SUBJECT: SEABROOK STATION, UNIT NO. 1 - RECEIPT OF DRAFT RESPONSE
FROM LICENSEE CLARIFYING QUESTIONS RELATED TO A
REQUEST FOR ADDITIONAL INFORMATION (TAC NO. MC8554)

DRAFT RESPONSES TO POTENTIAL SEABROOK RAI SEPTEMBER 6, 2006

The following is a draft of responses to the draft RAI received by FPL Energy-Seabrook from the NRC on 8-29-06 via an e-mail from Mr. G.E. Miller (USNRC) to Mr. M. O'Keefe (Seabrook). These draft responses are provided to facilitate discussions between the NRC reviewer and the licensee to clarify the prior response to an NRC RAI. Each question is reproduced followed by the response to the question.

DRAFT
Figure 3-2

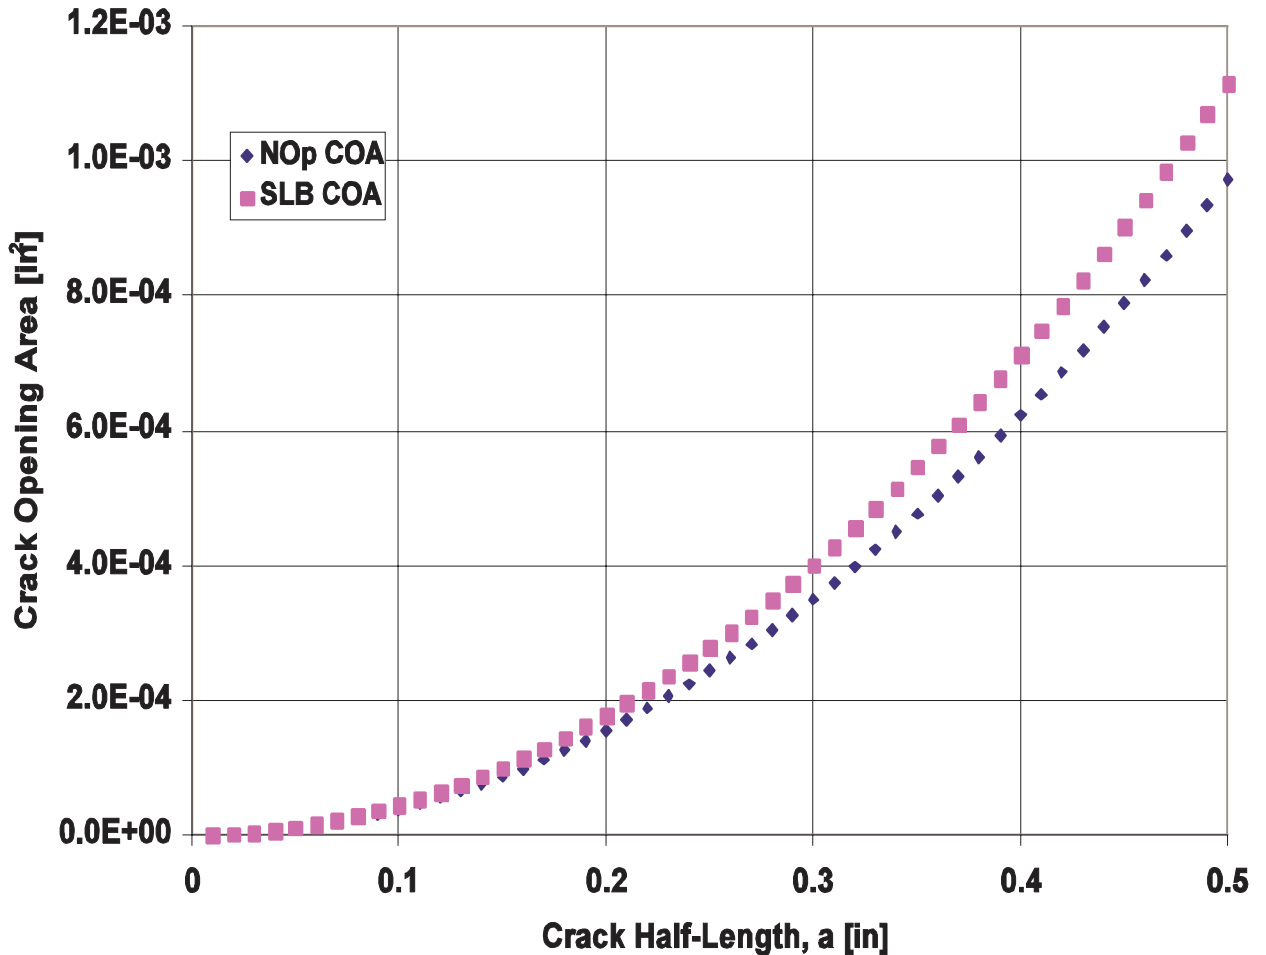
3. *Regarding FPL Energy Response 5 in Reference 2, provide a plot of COA for circumferential cracks located 4 inches from the bottom of the tubesheet as a function of crack length and tubesheet radius location for normal operating and main steam line break conditions. Provide a plot of leak rate as function of the same parameters, neglecting the effect of crevice resistance.*

As requested, Figure 3-1 and Figure 3-2 are plots of the circumferential and axial crack opening area, as a function of crack length, for both the normal operating (NOp) and main steam line break (SLB) conditions. The crack opening area models are independent of tubesheet radius. The results shown below include the more conservative estimates for a crack above the H* elevation (i.e., worst case) in the tubesheet.

Guided Axial Crack Opening Area as a Function of Crack Length
